MaineHousing's UFAS Clarifications (7/8/13)

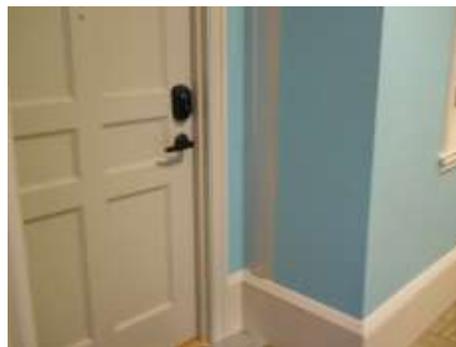
MaineHousing question: In reviewing and comparing these requirements we note that the more restrictive and dated is the UFAS location for the controls in the 30" by 60" wide roll-in shower and there is no discussion or recognition of the installation of seats in such showers. The more recent ANSI (2003) and 2010 ADA standards (2004 ADAAG) are very similar and we submit that these more recent standards specifically address the reach/usability issues related to control and shower head locations in 30" by 60" wide roll-in showers. We anticipate that the State of Maine may likely be adopting a more recent version of ANSI A117.1 shortly, so we are fairly confident that ongoing

In an effort to eliminate the identified conflict, provide design flexibility consistent with nationally recognized accessibility standards, and to control construction costs, we would like to request that HUD accept the 2010 ADAAG requirements as providing control and shower head locations compliant with the accessibility needs of our tenants, thereby relieving the identified conflict with UFAS. Without such a reciprocity acknowledgement/acceptance by HUD, we will need to provide duplicate controls in two different locations (an added cost to the projects) within 30" by 60" roll-in showers with seats; or not allow seats to be installed in 30" by 60" wide showers and provide controls per the UFAS specific location (developers prefer having the seats installed as part of the initial construction, providing maximum flexibility of use of the shower); or provide separate living units that comply with each of the different standards which will also be very costly.

HUD answer: *"I have received an answer from my supervisor regarding the accessible showers. If the shower provides greater access, the MSHA can accept the 2010 ADAAG standard. This standard is not required by the VCA, but is required by the ADA regulations after March 12, 2012."*

MaineHousing is very comfortable that the 2010 ADA Standards for Accessible Design (which include ADAAG 2004) are much better in addressing the roll-in shower controls locations and provide a higher level of accessibility. Using these standards eliminates a conflict with UFAS and will not increase construction costs.

Figure 404.2.4.3
Maneuvering Clearances at Recessed Doors and Gates

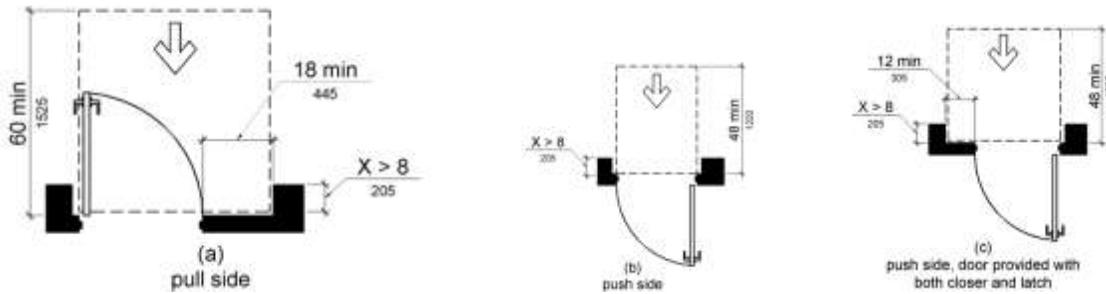
MaineHousing question: We have a situation with an apartment entry door with spring loaded hinges (which act like a closer) to an accessible unit (right-hand picture below) and we interpret that we need 12" minimum clear on the latch side/push side of the door (Fig. 25 (a)). Is there a maximum thickness of the wall in which the door sits? In our case we have a 24" thick wall (usually only 5" plus/minus) within the 12" space and the door is mounted to the inside of the 24." Other codes suggest that the maximum thickness is 8" from the door trim to any obstruction within the 12" clear space required, but I don't see anything specific in UFAS.

HUD answer: *“UFAS has no thickness requirements.”*

The HUD response is not very helpful in providing guidance; in situations like this it is generally advisable to take the next step of researching what the 2010 ADA standards have to offer as meeting Fair Housing requirements is necessary as well. In this instance, Figure 404.2.4.3 provides a great reference and guidance in analyzing such situations and, as such, it is prudent for MaineHousing to assure compliance using these standards.
